**Minutes of Pre-Bid Conference**

PROJECT: WBS 42575.3.1 / DO00124 / BK-5124 / Burke County Replacing  
Bridge No. 307

3. Revised bid sheet page 135 is attached adding a bid item for “Right of Way Markers.”
4. Revised plan sheet numbers 2, 3, 4, 5, 6, 7, 9, 10, 12 and 13 are attached, reflecting the changes of cast-in-place concrete barrier rails to precast concrete barrier rails.
5. Environmental permit information is attached.

1  
 3'-0" X 1'-9"  
 PRESTRESSED CORED SLAB UNIT

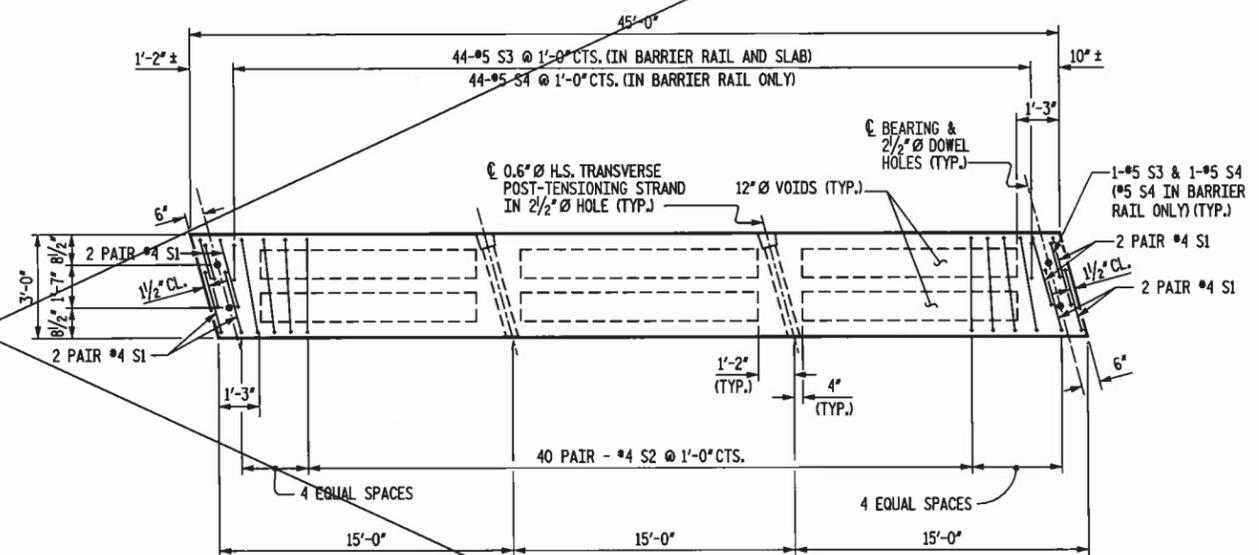
1 DELETE DRAWING.

1 BILL OF MATERIALS

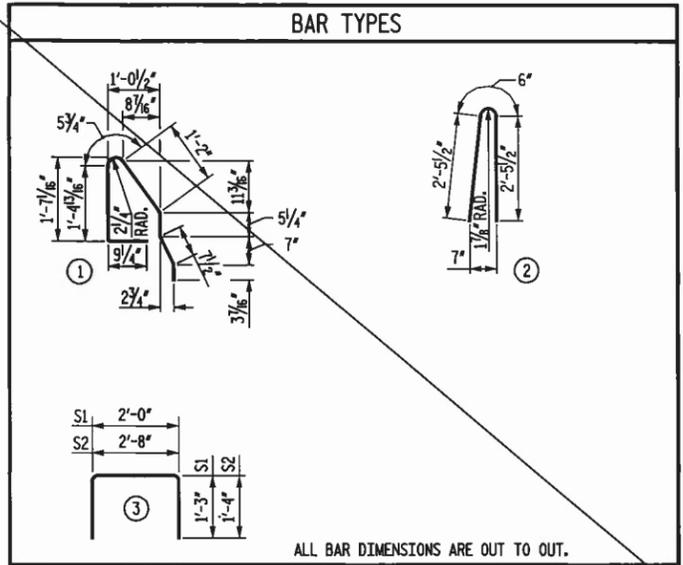
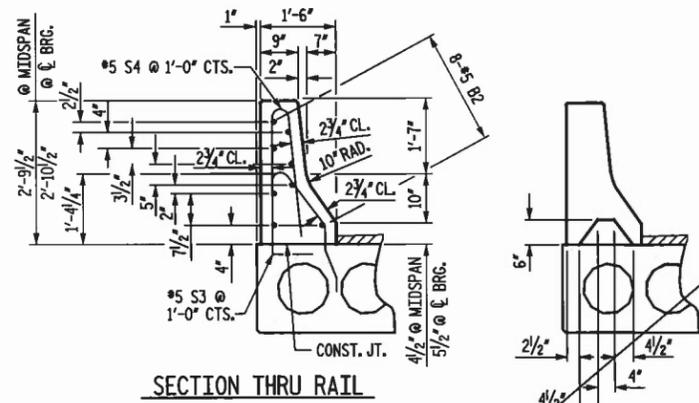
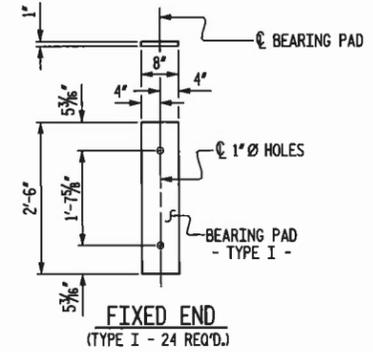
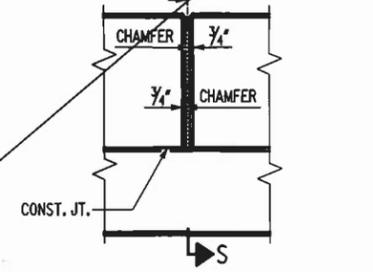
1 DELETE DRAWING.

STATE OF NORTH CAROLINA  
DEPARTMENT OF TRANSPORTATION  
RALEIGH  
SUPERSTRUCTURE  
GUARDRAIL ANCHORAGE  
DETAILS

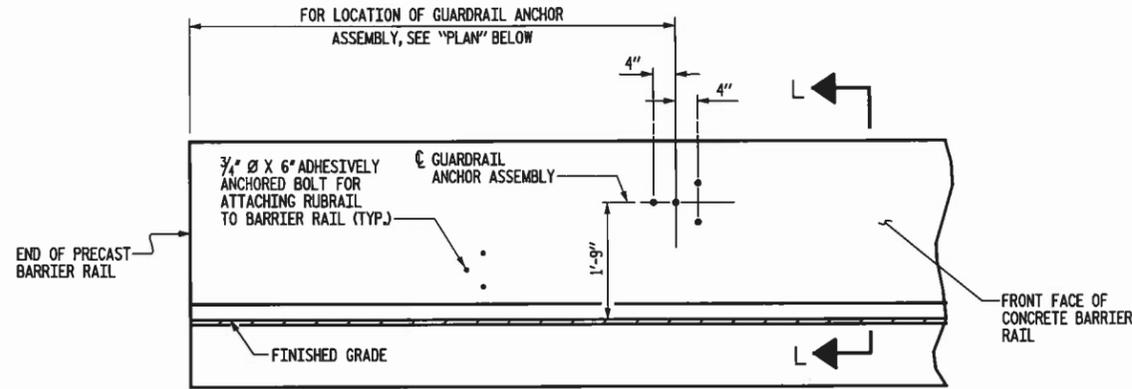
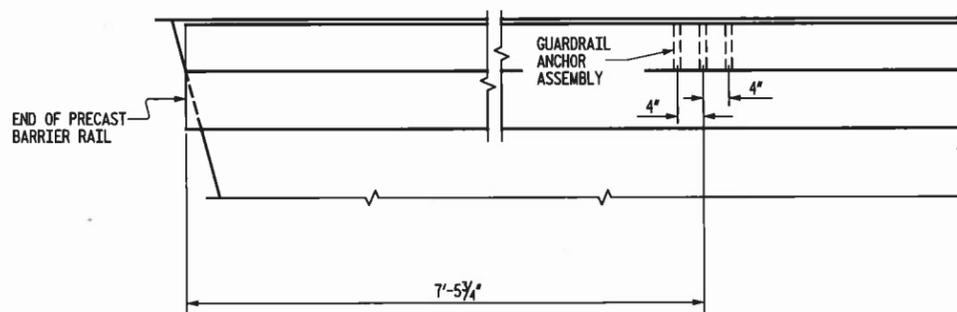
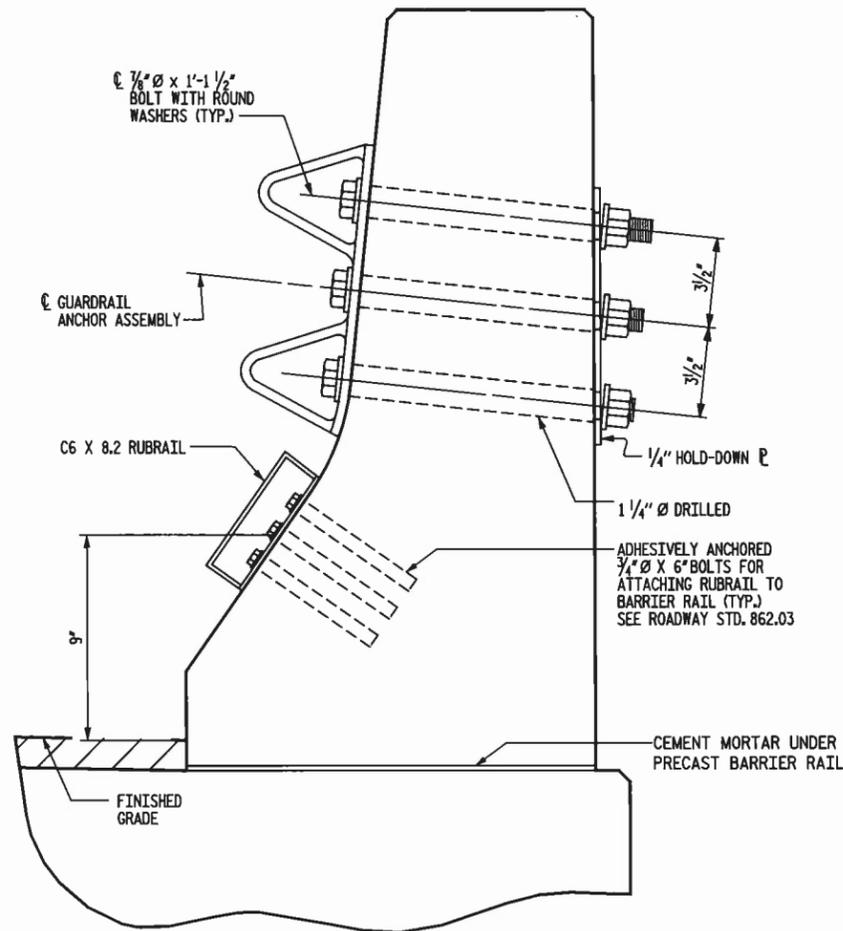
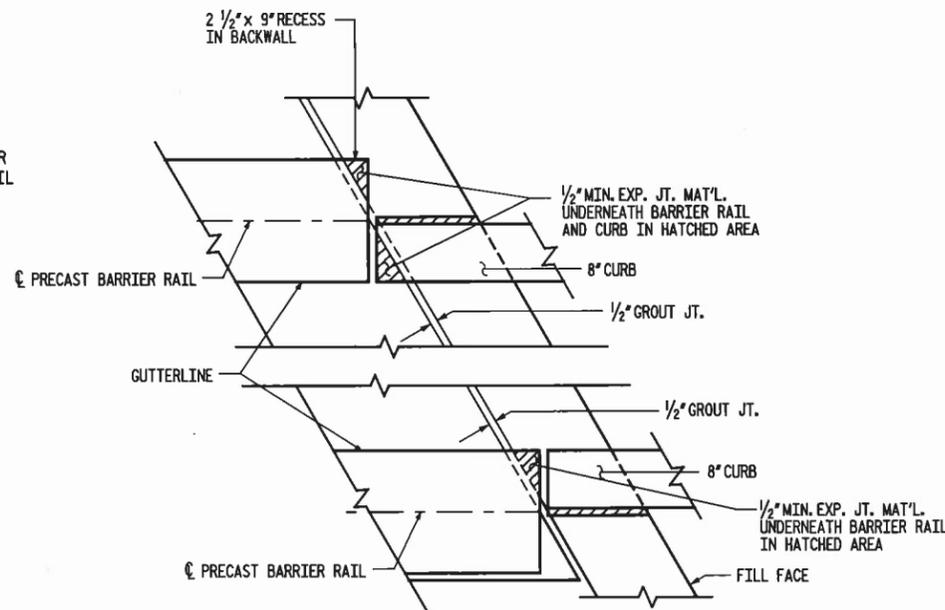
1 REPLACES DRAWING 6 (6-7-11)

1 SUBSTRUCTURE ABUTMENT NO. 1

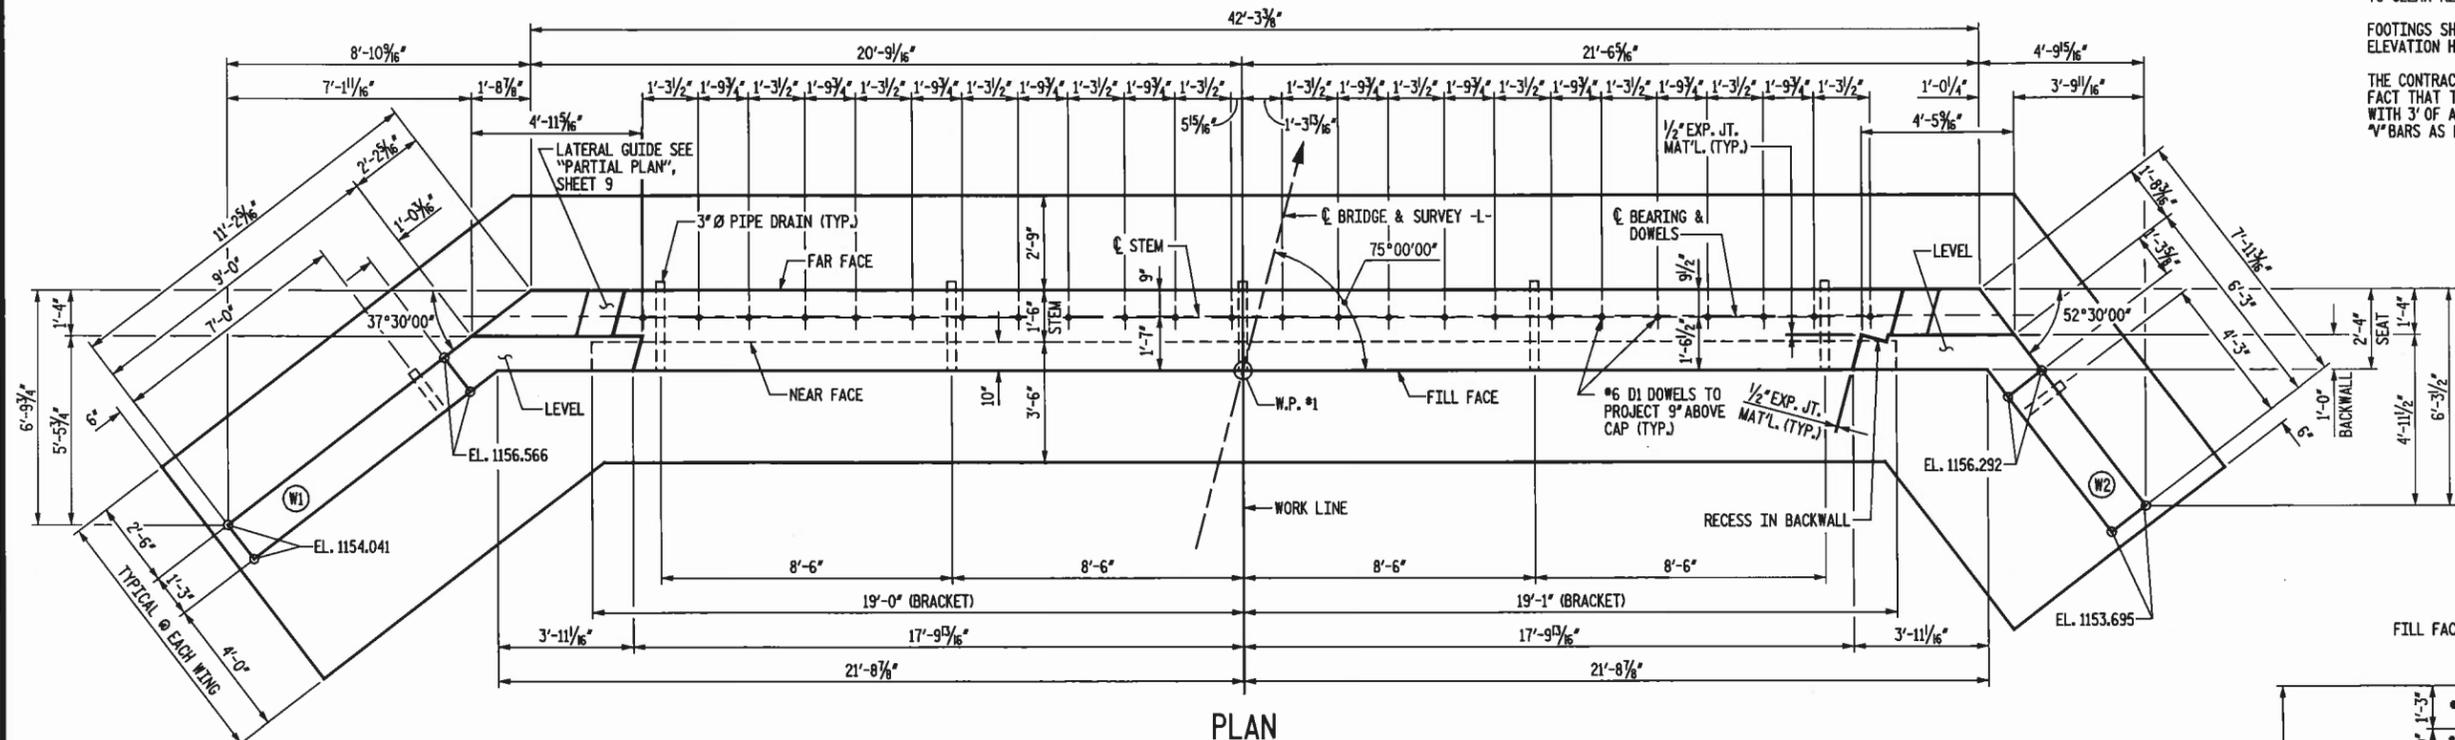
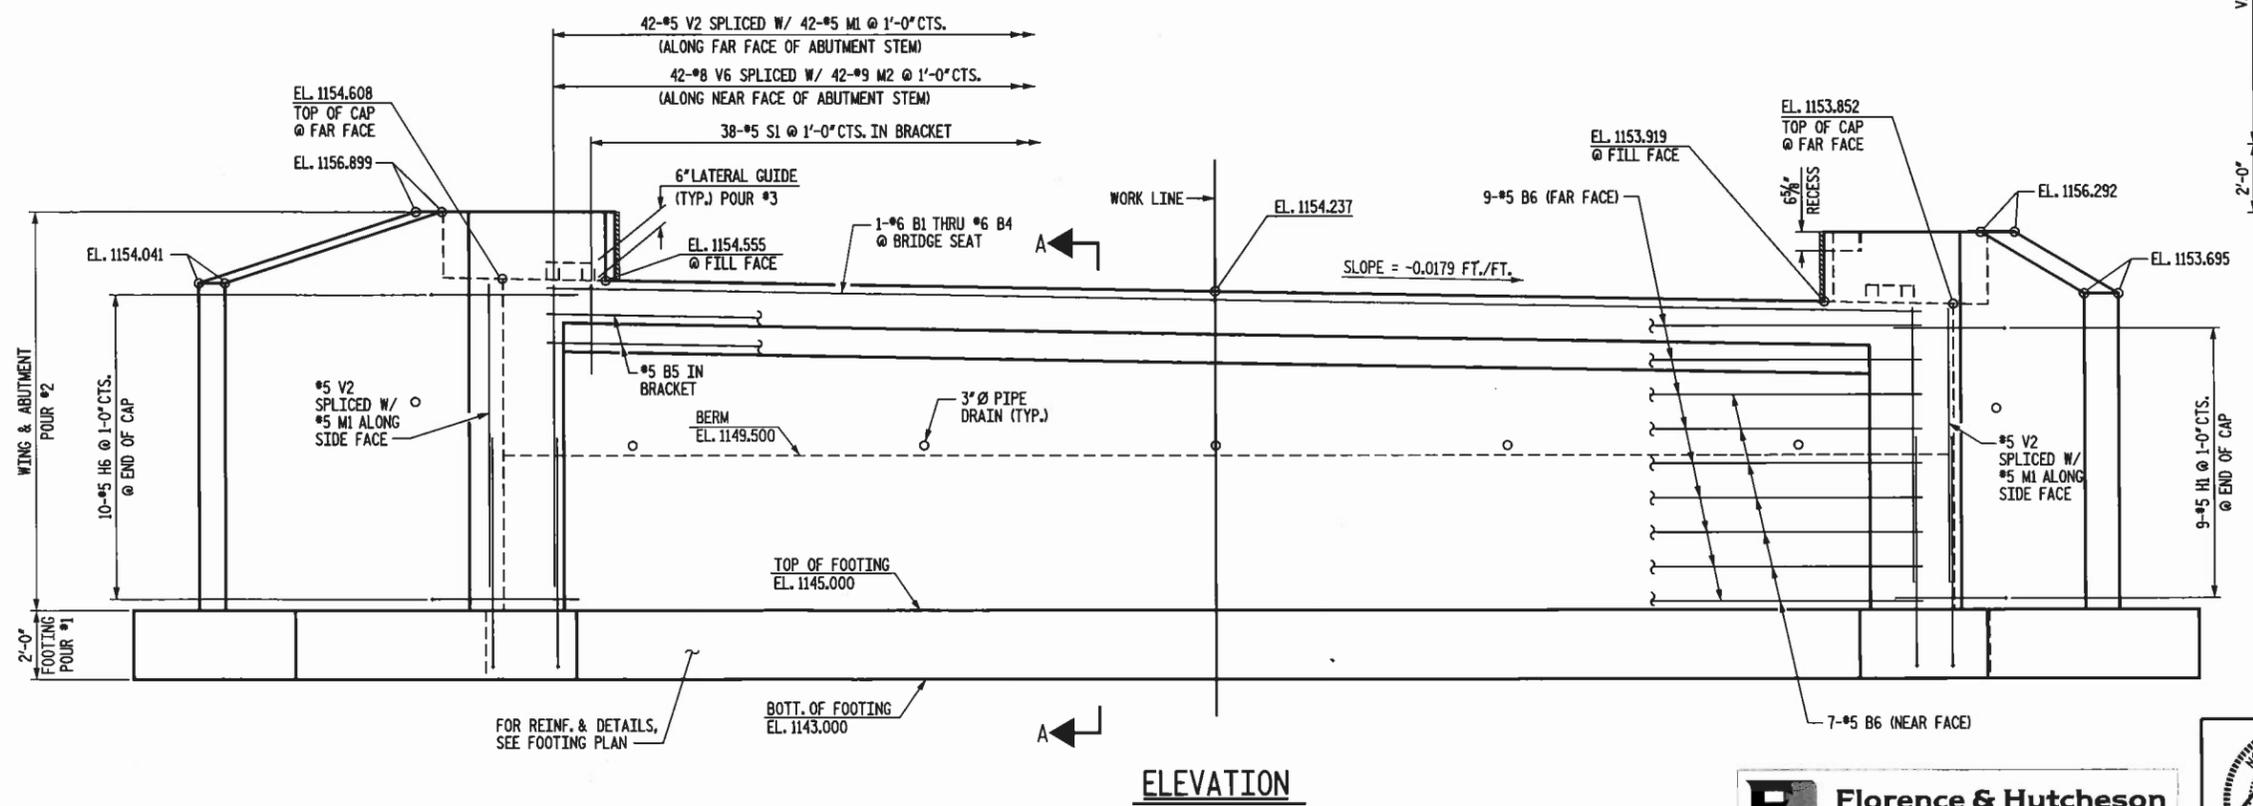
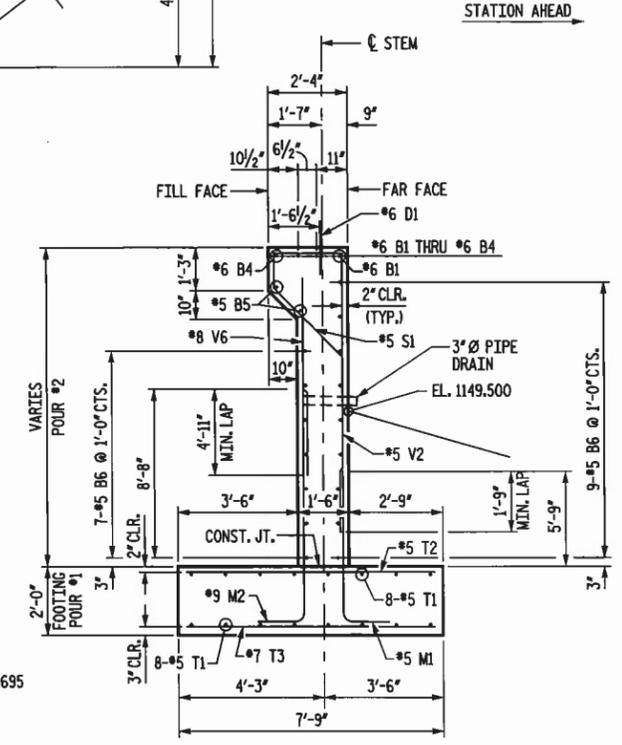
1 REPLACES DRAWING 7 (6-7-11)

1 SUBSTRUCTURE ABUTMENT NO. 1 WING DETAILS

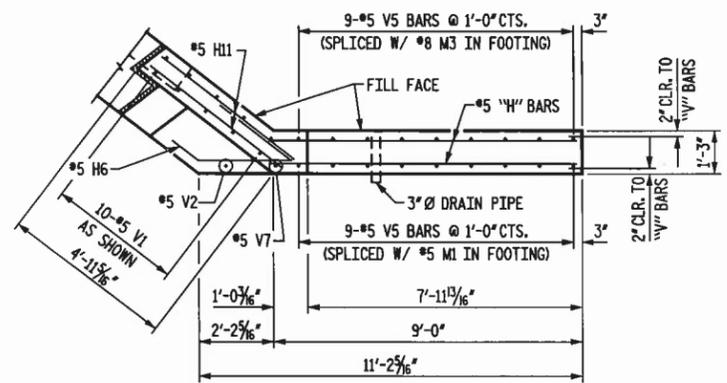
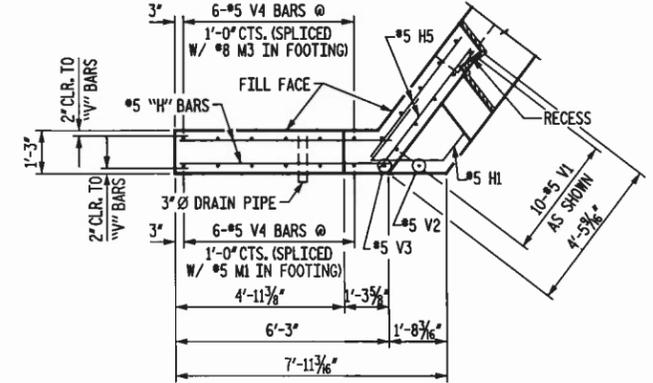
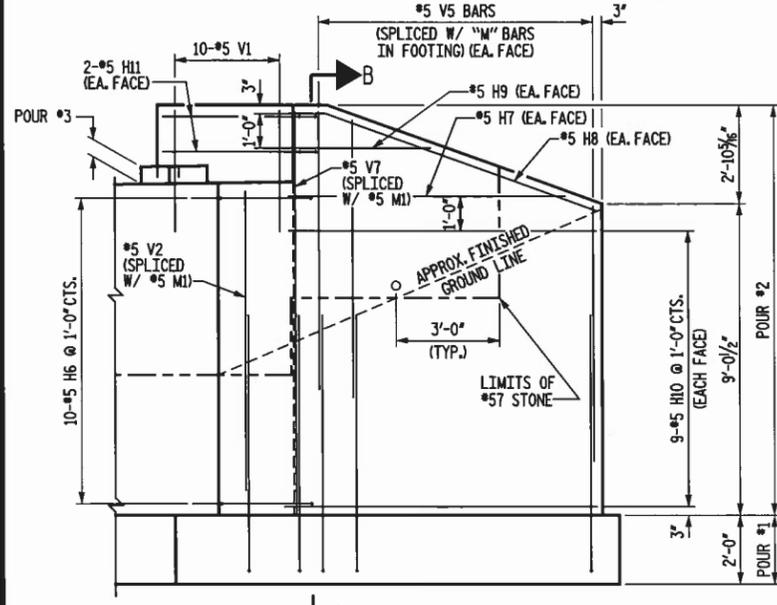
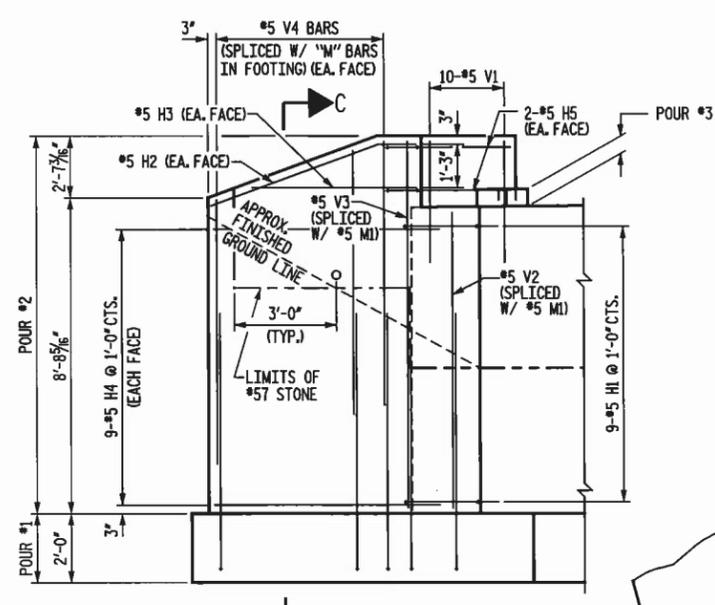
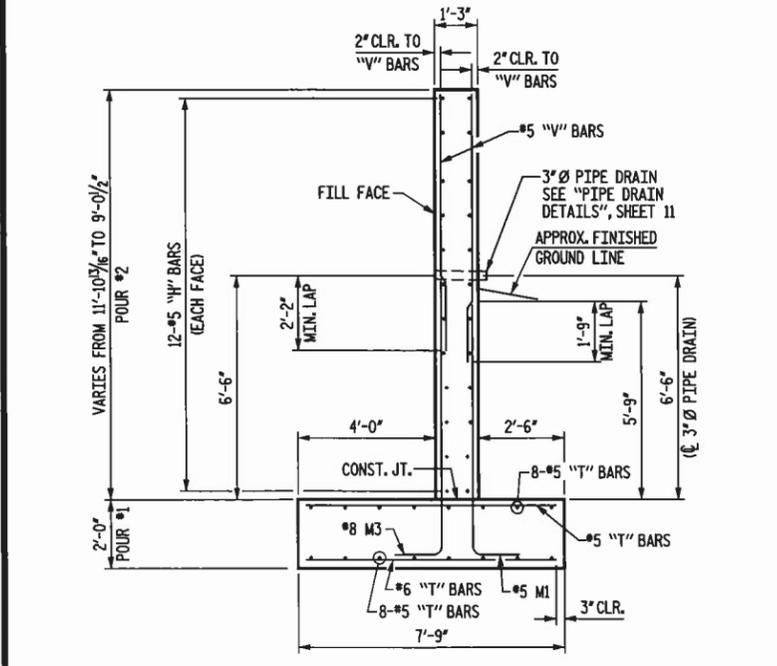
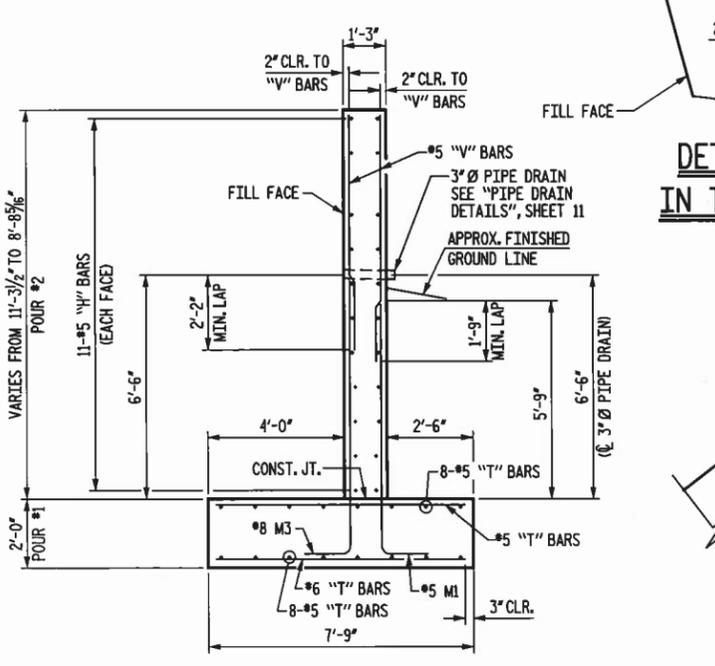
1 REPLACES DRAWING 9 (6-7-11)  
PROJECT NO. 42575  
COUNTY: BURKE  
STATION: 16+14.15  
REPLACES BRIDGE NO. 307
